Sample Approval Form

Customer: Centra
Attention: Jagdeep Singh
CSR: Nicole Teplan
Die #: 15957 (Old number: 5495)
Description: (240 SERIES)
FIXED PICTURE FRAME
CROSS-SECTIONAL
DETAILS **Rigid Colour:** WH-115
Flex Colour: BLACK
Capstock Colour: N/A

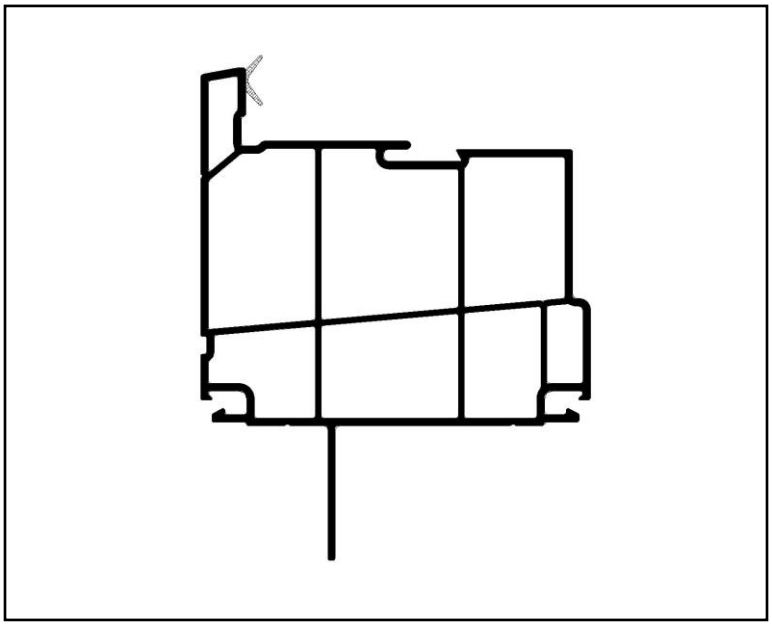
Comments: The die drawing is approved with critical dimensions identified on Vision drawing. Weight control limits apply. Nail fin to be updated to slotted hole. The physical sample is approved with the dimensions received on the upper limits of wall thicknesses. It is further understood that as the die weras out the wall thickness will drift to thicker end of tolerance.The negative impact of thinner wall and overstretching during extrusion on thermal deformation of profiles is acknowledged by Vision. Thinner walls also compromise the structural attachment of Centra product.Normal distribution around the target thk is acceptable, but consistently thinner profile will not be acceptable.
